TOWN OF ARLINGTON

CONSERVATION COMMISSION

**RE: 1165R Mass Ave – Application for Comprehensive Permit
Third Set of Comments from Conservation Commission – Waiver Requests**

SHEET TITLE:
PROPOSED AURA EXHIBIT
 SHEET NUMBER:
1
 ORG. DATE - 05/24/2021

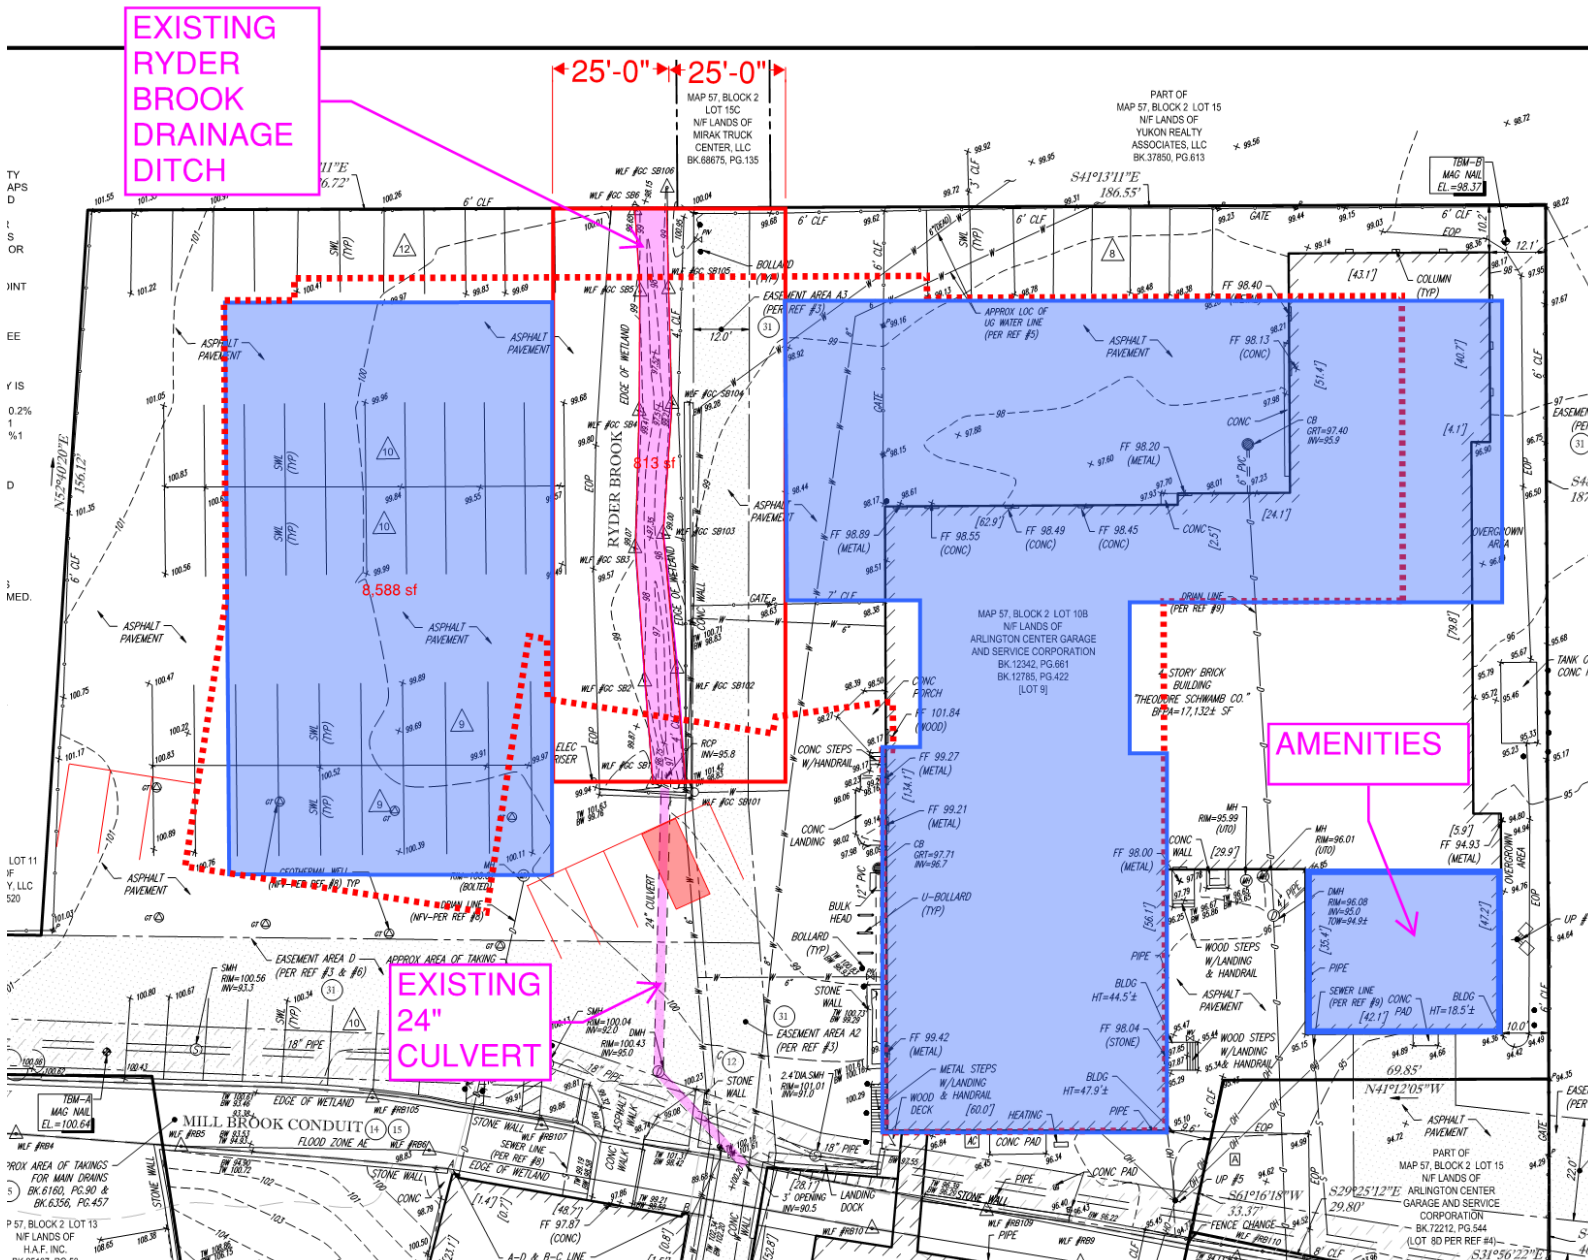
<p>Regulations, Section 25D – 25’ No Disturbance in Adjacent Upland Resource Area (AURA) Performance Standards This Waiver request was withdrawn via Applicant’s Legal Counsel letter dated June 7, 2021.</p>	<p>ACC disagreed with this waiver request and agrees it should be withdrawn. <u>Justification:</u> ACC maintains that the project as proposed is in compliance with Section 25D because the plan proposes mitigation to increase the pervious area in the 0-25’ AURA by 1,505 square feet, which is considered an enhancement of the resource area, as allowed with local approval. As shown in Attachment A of this letter, Mary Winstanley O’Connor, the Applicant’s Legal Counsel, provides a letter stating that the project as proposed complies with Section 25D and the Applicant withdraws this waiver request. Proof of compliance with Section 25D is detailed in Attachment B, Proposed AURA Exhibit, prepared by Bohler Engineering.</p> <p>ACC Recommendation: no further action required.</p>
